Disability Access Compliance Statement

**To accompany a Development Application for a new
Modular Classroom Building at William Carey Christian School,
38-44 Bumbera Street, Prestons NSW**

Prepared by Urban Pathways Pty Ltd

4 February 2025 –Rev2

Figure 1: Existing Site Plan. Source: Gardner Wetherill Assoc Architects

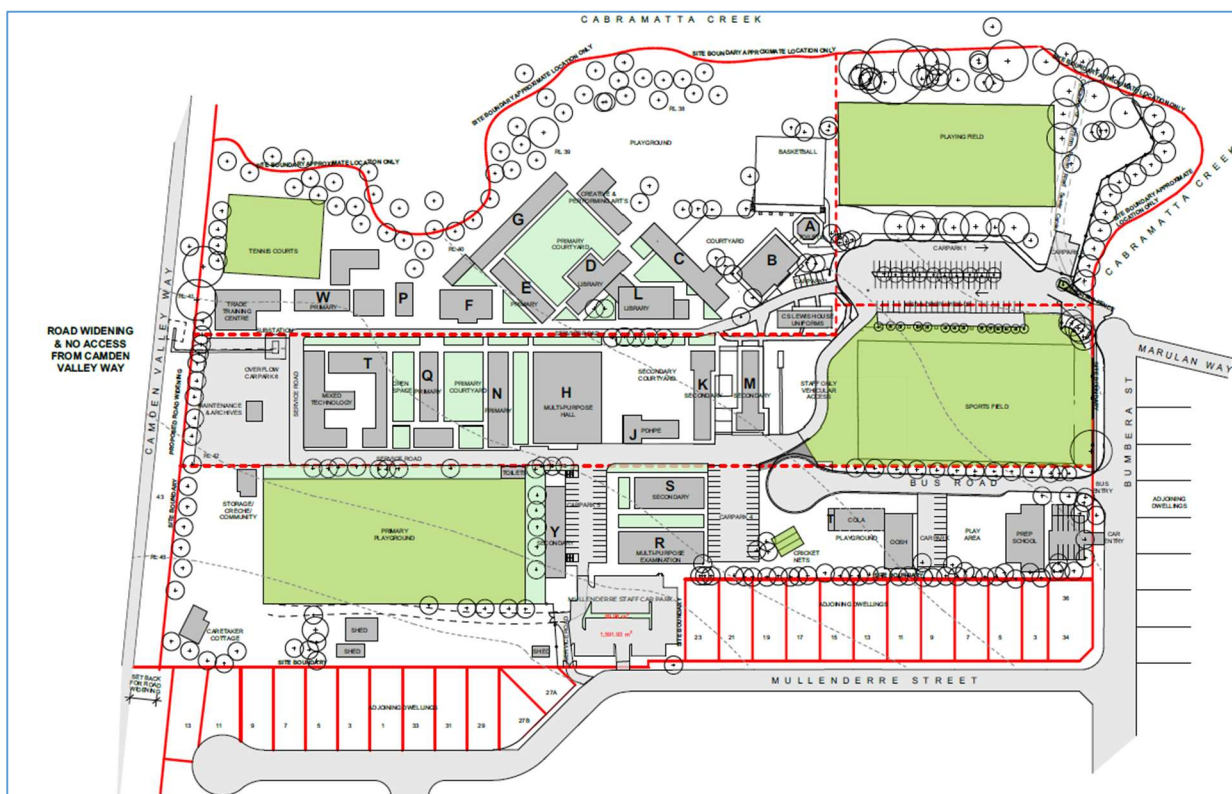
Overall, the paths of travel from the entry points and car parking spaces to the new building, and within the school site provide firm and level step-free paths of travel.

However, some technical departures were noted from the detailed provisions of AS1428.1-2009 in relation to some paths of travel, as summarised in the table below.

Location / Element	Compliance Issue	Photo
Main Entrance - Uneven surface at site boundary	The bitumen pathway narrows and the edge drops away at the site boundary. AS1428.1-2009 requires the edge of an accessible pathway to continue at the same level unless there is a kerb or wall. Abutting surfaces should have a level difference no greater than 2mm (or 5mm if the edge is bevelled or rounded).	
Main Entrance – Steep sections of pathway, and crossfall/camber	Sections of the pathway to the school have steep gradients (up to 1:16) and crossfalls (up to 1:11). AS1428.1-2009 defines any walkway with a gradient steeper than 1:20 is defined as a ramp. The standards require a ramp to have handrails on both sides and intermittently spaced level landings for rest. The standard also addresses crossfalls, which are to be no greater than 1:40, or 1:33 if the surface is bitumen.

Car Park – Barriers on Path of Travel	Fences, speed humps and gates impose access barriers for people moving from the accessible parking spaces to the school buildings. The route from the easternmost space is restricted by a fence on two sides, and therefore requires passage over a rounded speed bump. The dimensions of the speed bump makes it a barrier for people with disabilities under AS1428.1-2009.	 
Car Park – Barriers on Path of Travel cont'd	The route from the westernmost space (pictured at right) requires pedestrians to enter the school grounds via the central service road. During our site inspection, a retractable scissor-fence was in place to prevent access by vehicles. This also had the effect of preventing access by a person in a wheelchair.

Camden Valley Way Entry - Gates	This secure route requires pedestrians to use a ramp from the street (within Council land – not inspected), and then pass through 2 access pass-controlled gateways. The gates have a wide opening, D-lever handles and are self-closing, but are not fully AS1428.1-2009 compliant for wheelchair users as they lack door circulation (latch-side and hinge side clearance), and the width of the path does not accommodate 180 degree turns if access cannot be gained through the gate. In practice, this entry is unlikely to be used by a person in a wheelchair due to its secure access status, discrete nature (no school entry signage) and isolated location on a busy road. It could be determined that access is provided ‘to the degree necessary’ despite the identified issues	
--	--	---

Figure 4: Ground Floor. Source: Marathon Modular

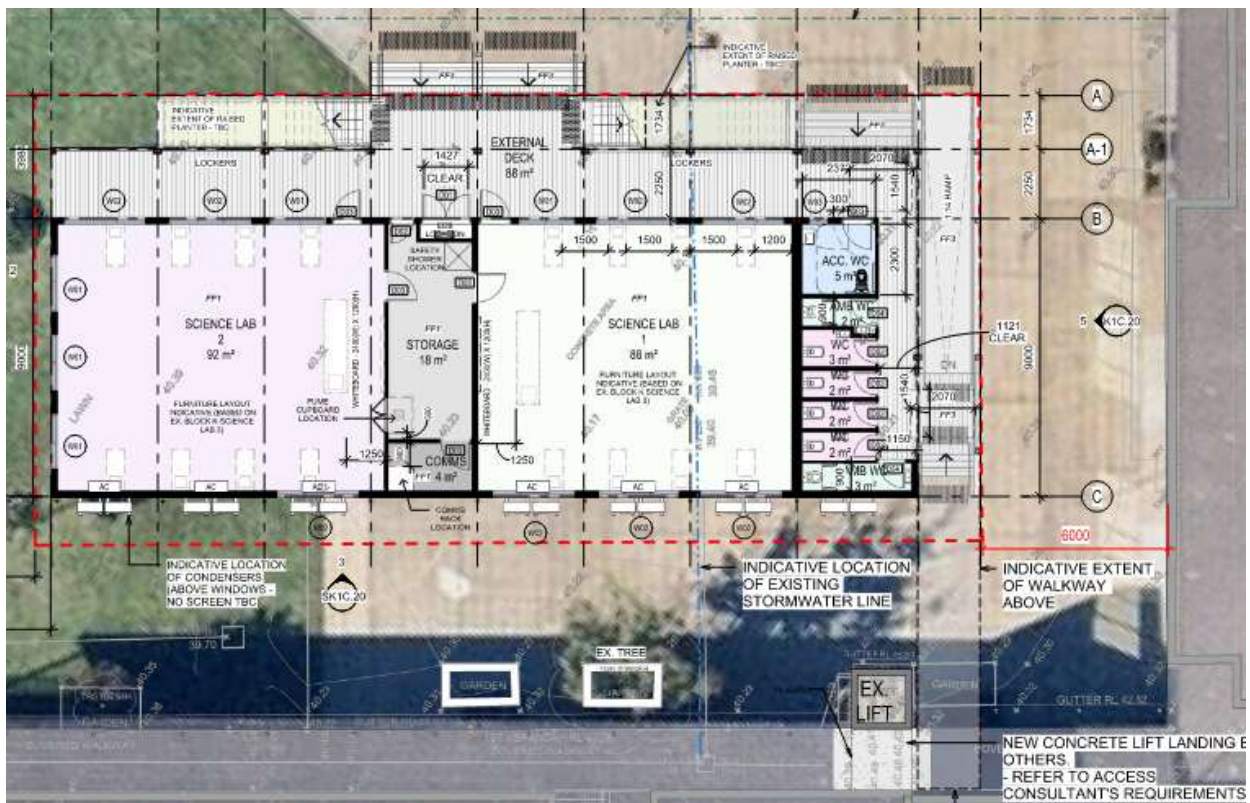
The ground floor of the proposed building is elevated above existing ground and is accessed by a 1:14 ramp and two flights of stairs from the playground.

NCC Deemed to Satisfy	Compliance	Comments
		entrances. Further, fully accessible entry doors into the storage room are shown to be provided from within the science lab classrooms. At CC stage: All doorways that are to be accessible shall be detailed to comply with AS1428.1-2009. This includes a minimum clear opening width of 850mm to all rooms required to be accessible, min clear opening width of 700mm for Ambulant WC cubicles, door circulation clearances, accessible door handles and luminance contrast at doorways.
D4D4 Parts of building to be accessible Stairways (non-fire isolated) stairways to be designed in accordance with Cl 11 of AS1428.1 (	Capable of DTS	The DA drawings include several flights of non-fire isolated stairways which are shown to be capable of DTS compliance. Subject to detailed design and assessment at CC stage, the DA stage drawings indicate allowance for suitable stairway clear width and dimensions, continuous handrails at landings and handrail extensions at the top and base, contrast stair nosing, and tactile indicators (TGSIs) at the top and base of each stair. Two different height handrails are shown, which reflects the requirement under NCC2022 Part D3D22(1)(c) for a second handrail located at a practical height between 665 mm and 750 mm in a primary school, to aid children. Details of the above to be checked at CC.

Ramps to be designed in accordance with Cl 10 of AS1428.1 (gradient, length, landings, handrails on both sides, clear width, TGSIs)	Capable of DTS	The DA drawings include two ramps –from the playground to the ground floor, and from the first floor to Level 1 of Building G – which are shown to be capable of DTS compliance. Subject to detailed design and assessment at CC stage, the DA stage drawings indicate that allowance has been made for compliant 1:14 gradients, suitable clear width and length, landings at the top and base of ramps, and mid-way where necessary, compliant handrails on both sides, continuous handrails at landings and handrail extensions at the top and base, and tactile indicators (TGSIs) at the top and base of each ramp. Two different height handrails are shown, which reflects the requirement under NCC2022 Part D3D22(1)(c) for a second handrail located at a practical height between 665 mm and 750 mm in a primary school, to aid children.

F4D5 Accessible sanitary facilities - Provision of accessible unisex sanitary compartments in accessible parts of the building - Included elements, circulation spaces, fixtures and fittings to comply with the requirements of AS1428.1.	Capable of DTS	The DA drawings indicate that compliance can be achieved with the following DTS provisions in F4D5, subject to detail at CC stage: - An accessible unisex sanitary compartment is to be provided in an accessible part of a building. - It is located so that it can be entered without crossing an area reserved for one sex only. - It is shown to contain a closet pan (toilet) and washbasin, and can accommodate a shelf or bench top and sanitary product disposal bin - The room dimensions are sufficient to accommodate circulation spaces, fixtures and fittings to comply with the requirements of AS 1428.1 at CC stage.
Provision of Ambulant sanitary compartments for males and for females, each in accordance with AS1428.1	Capable of DTS	The NCC requires that at each bank of toilets where there is one or more toilets in addition to an accessible toilet, not less than one sanitary compartment for a person with an ambulant disability for use by males and not less than one sanitary compartment suitable for a person with an ambulant disability for use by females, each in accordance with AS 1428.1, must be provided (ie toilet cubicle) for ambulant disabilities for males and one for females is to be provided. The DA drawings indicate that compliance can be achieved with the following DTS provisions in F4D5, subject to detail at CC stage: 2 ambulant cubicles are identified. - At this stage, the drawings do not identify whether the 2 ambulant cubicles are for male and female or are unisex. - As highlighted above, the NCC does not allow for <i>unisex</i> ambulant toilets as DTS. Thus, where

Figure 5: First Floor. Source: Marathon Modular

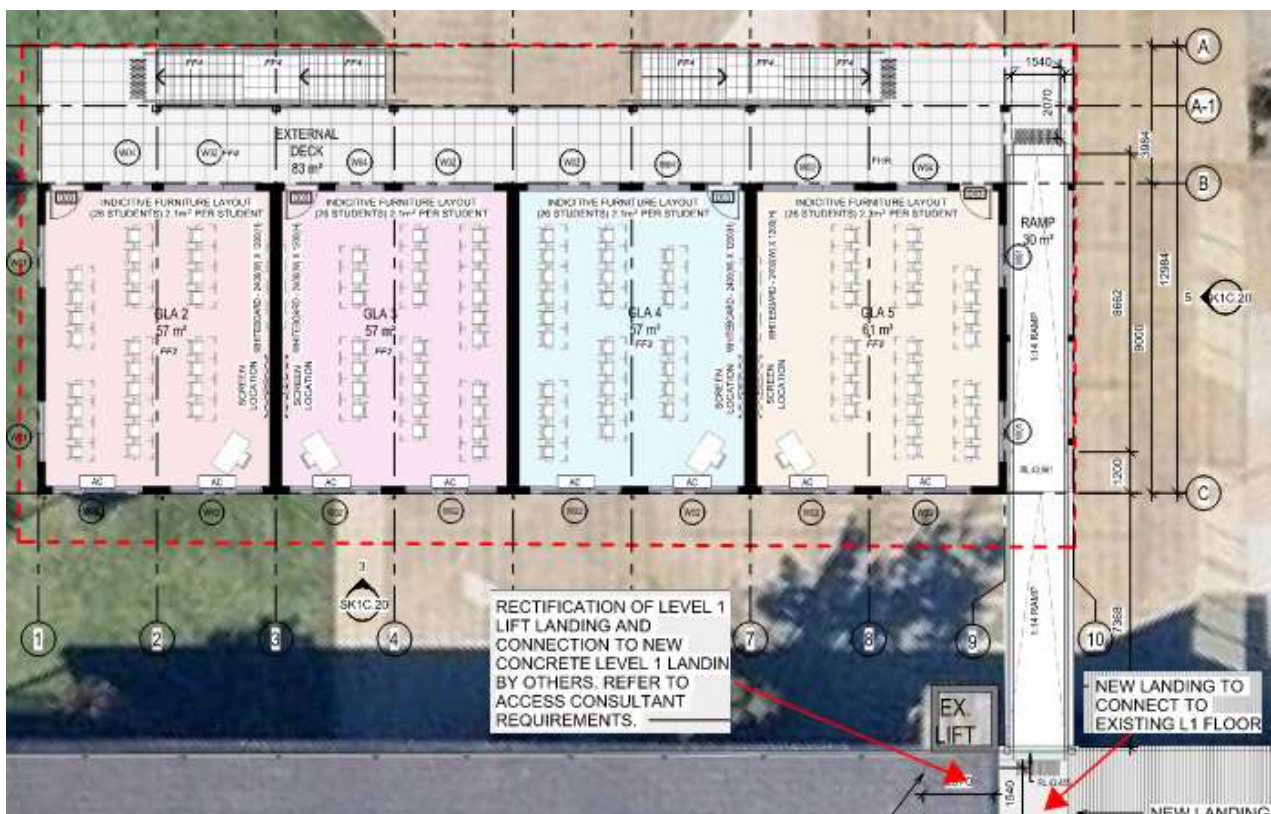
The first floor is reached via two flights of stairs from the ground floor deck. In addition, to provide an accessible path of travel to the first floor, the proposed building will incorporate an elevated ramp / walkway connecting to Level 1 of the adjacent Building G. This will enable the use of the existing passenger lift which services Building G.
